Oconee Nuclear Station (ONS)
Docket Nos. 50-269, 50-270, 50-287

Subject: Duke Energy Carolinas, LLC (Duke Energy)
Quality Assurance Program Topical Report Amendment 40

Change 1 Description: Organizational description in Section 17.3.1.2 was revised to reflect changes resulting from the merger between Duke Energy and Progress Energy and to incorporate subsequent organizational changes.

Figure 17-2. Corporate and Offsite Organization

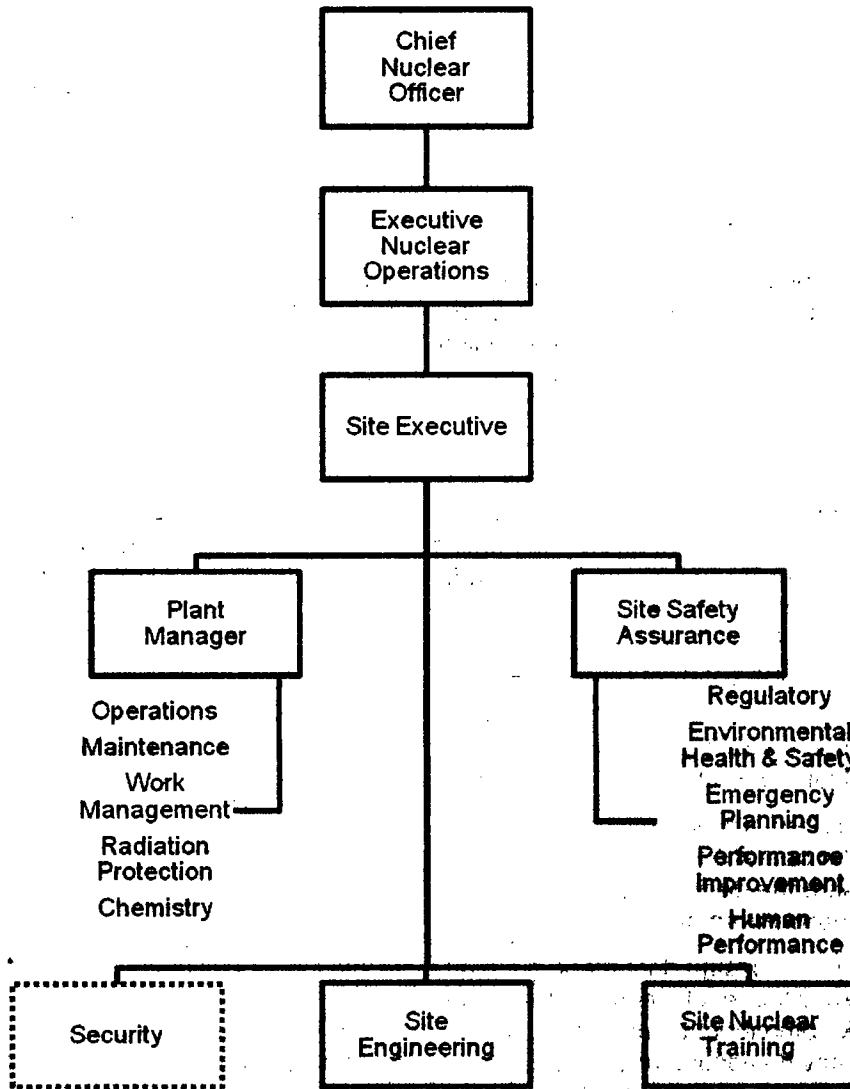
The Organization Description in Section 17.3.1.2 was next revised to identify a senior executive position between the Chief Executive Officer and the Chief Nuclear Officer. The Chief Nuclear Officer (CNO) remains the corporate executive responsible for quality assurance (QA) and remains the highest level of management responsible for establishing Duke Energy Carolina's QA policies, goals, and objectives. The CNO has overall responsibility for Duke Energy's operating nuclear power plants. The CNO reports to a senior executive who is also responsible for the non-operational functions of nuclear plant development, nuclear plant decommissioning, and project management & construction. Additionally, Nuclear Oversight in Section 17.3.1.2.2.b is revised to clarify the continuing oversight responsibilities for nuclear plant development and decommissioning.
